MEMORANDUM

To: Paul Stoddard, Planning & Zoning Director
From: Dave Brown
Subject: SUP 2025-00056
Date: December 2, 2025

ZONING DATA
PROPERTY LOCATED AT
2 WEST HOWELL AVENUE
INSTRUMENT #000024261
CITY OF ALEXANDRIA, VIRGINIA

Exhibit 1

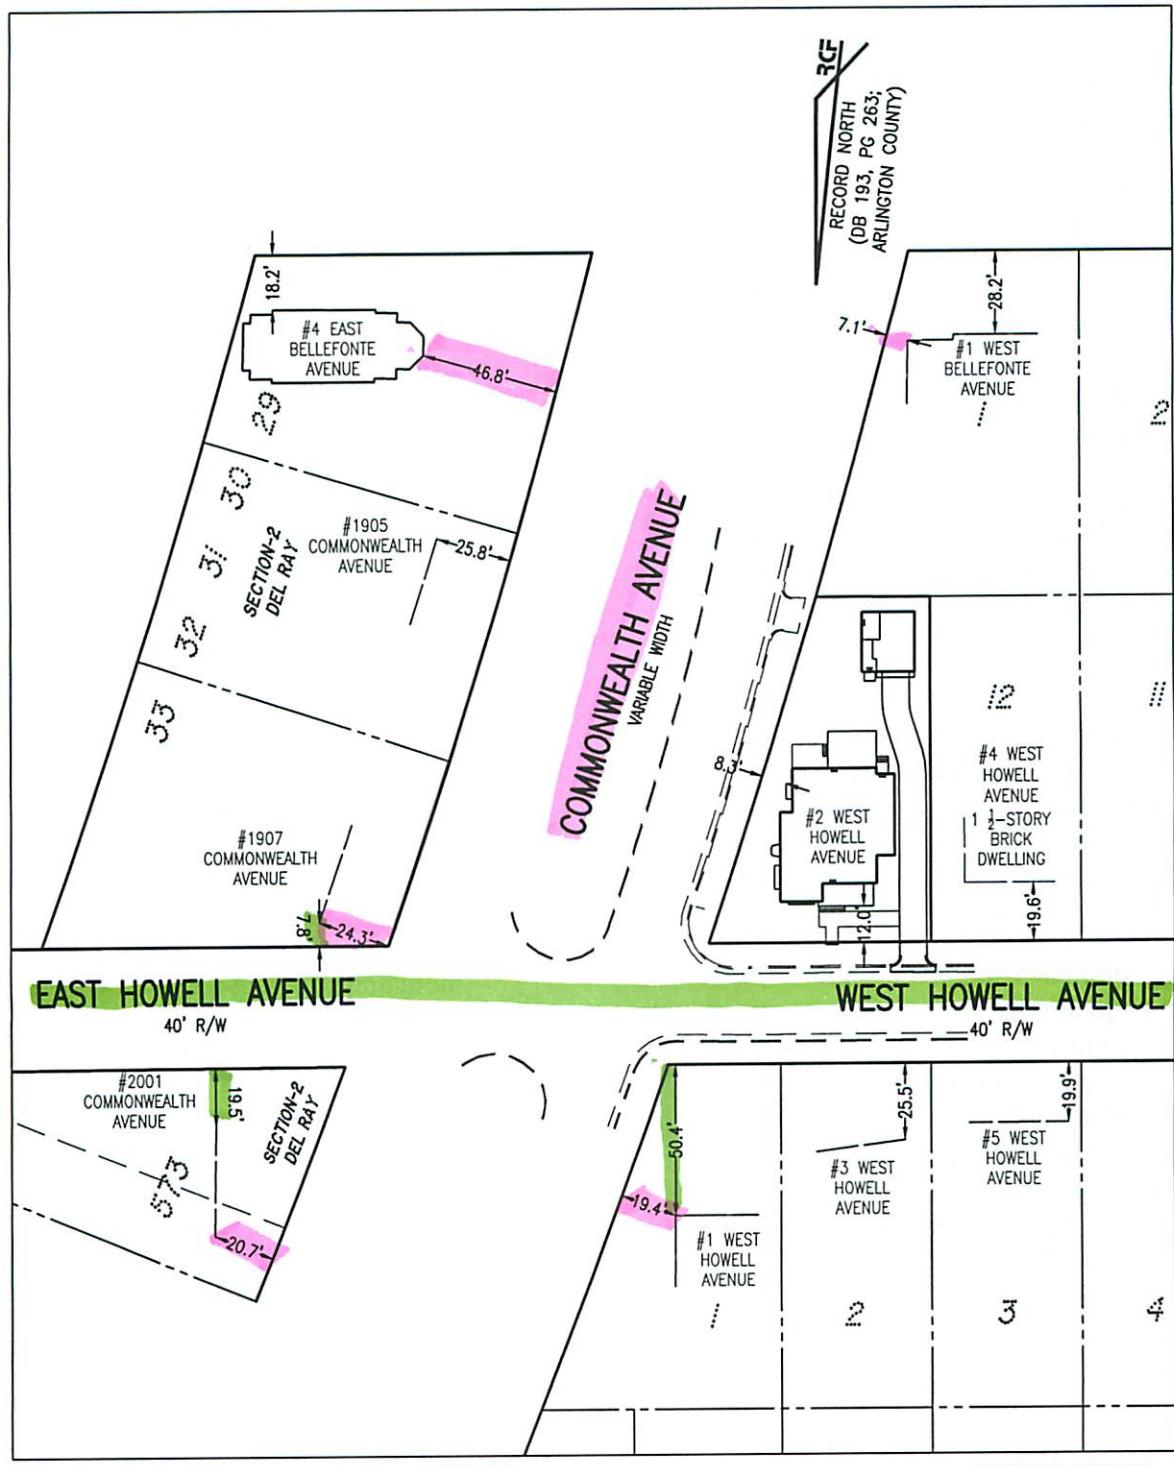
While staff and I are in agreement on the foregoing, the Ordinance does not specify how the range (and thus, the minimum) is to be determined. The methodology employed by the staff, mirroring the illustration shown in the 2019 Staff Report when the conceptual block face became the established framework for front yard setback calculations, was to establish a range for each street facing the subject corner lot. This is shown in Exhibit 1, applying the staff methodology to this case. It shows that there are three corner lots with yards facing Howell, ranging from 7.8' to 50.4', as shown in green. It also shows that there are five corner lots with yards facing Commonwealth, ranging from 7.1' to 46.8', shown in pink. Looking at the minimums for both streets, staff concludes that the yard facing Howell must be at least 7.8' and the yard facing Commonwealth must be at least 7.1'. Staff thus finds no fault with the proposed yards of 12.7' on Howell and 8.8' on Commonwealth. [The interior lots in the conceptual block face are immaterial to finding the minimum in this instance, in that all of their front yards are above the minimum among the corner lots.]

Exhibit 2

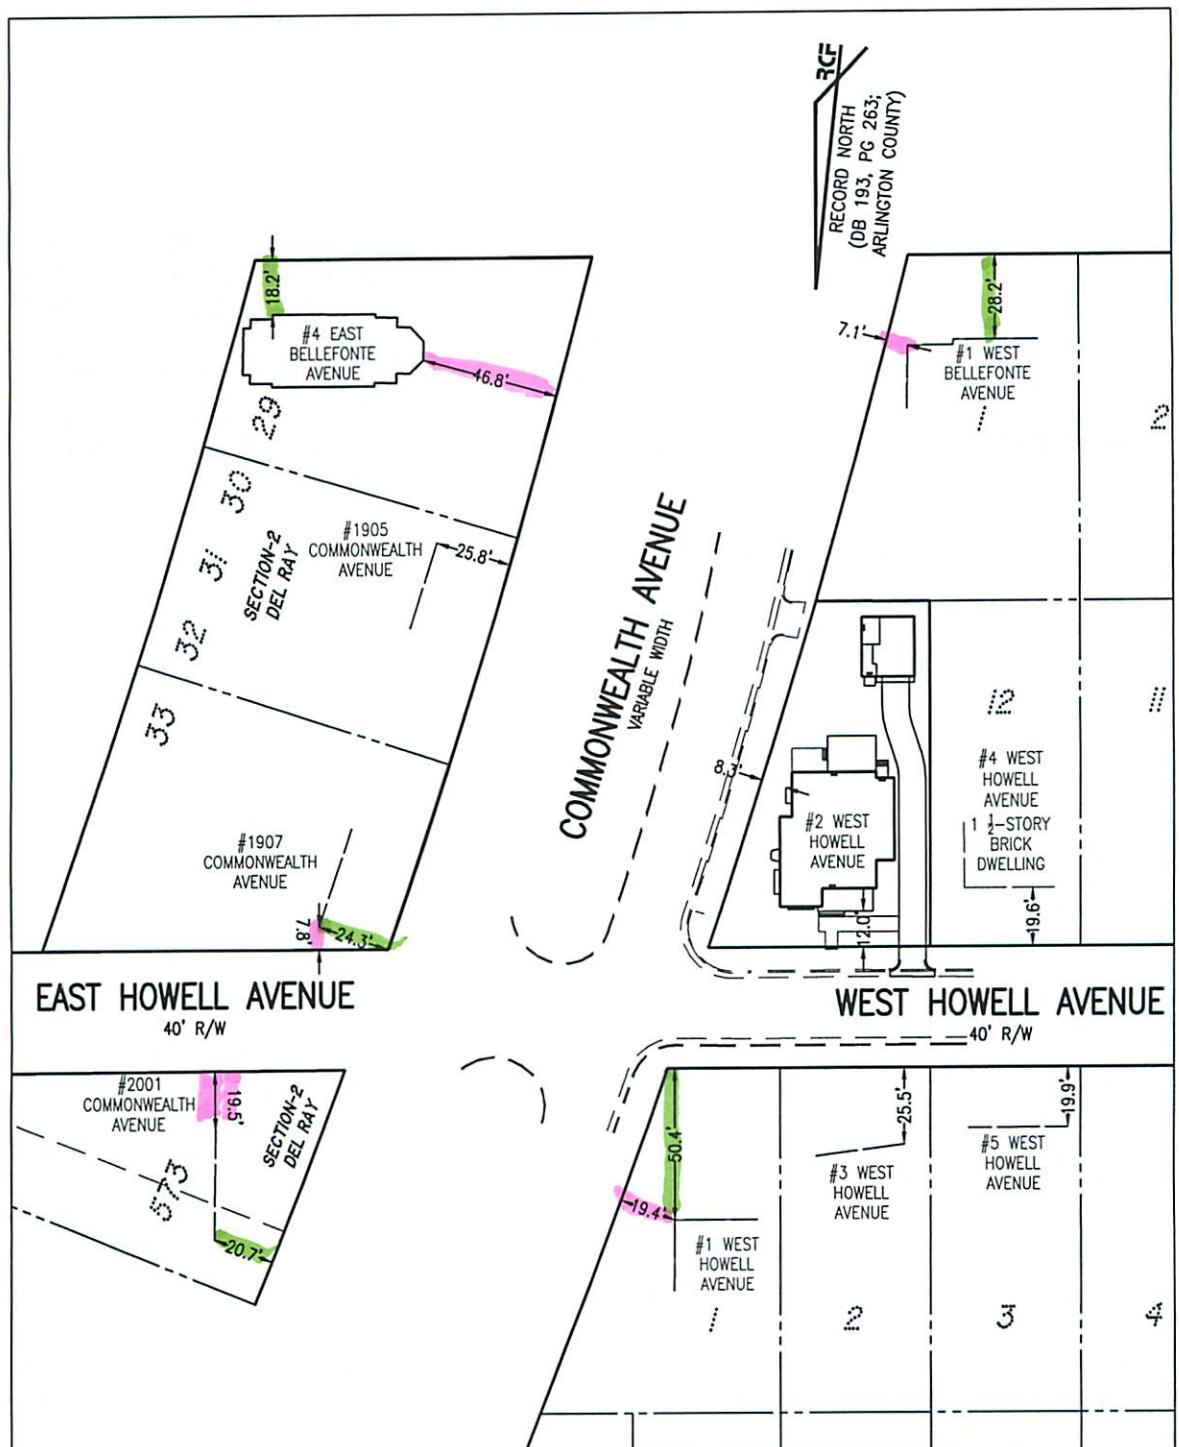
entrance to the building, deemed "primary", and the "other front yard" where, whether there is a street-facing secondary entrance or not, it is deemed "secondary." Exhibit 2 is based upon respecting this corner lot front yard distinction that preceded enactment of the contextual block face in 2019.¹ In my methodology, apples are compared to apples (primary front yards), and oranges to oranges (secondary front yards). I show all the primary front yards in the block face in green and all the secondary front yards in pink. The shortest primary front yard is 18.2' at 4 East Bellefonte, and the shortest secondary front yard is 7.1' at 1 West Bellefonte. Hence, while the applicant remains free to designate the streets the primary and secondary yards at 2 West Howell will face (by deciding on the location of the main entrance to the dwelling), the primary front yard must be set back from the chosen street at least 18.2' and the secondary yard must be set back from the other street at least 7.1'. In this case the secondary front yard, at 8.8' is above the minimum, but the primary front yard, at 12.7', is more than 6' short of the minimum.

You responded to me that "the contextual block face analysis is completed without identifying a primary or secondary front yard," and that the "selection/designation of the primary front yard is left to the owner." But as is self-evident, my analysis of the contextual block face is completely independent of what the applicant has chosen as his primary front yard. The analysis looks only at what has already been chosen by the other corner lots in the contextual block face; they have made their choice evident by the selection of the street on which their main entrance now faces. Those choices must be viewed as a "done deal," and they are the ones that ought to drive the determination of the ranges to be used in this case for both the primary and secondary front yards minimums.
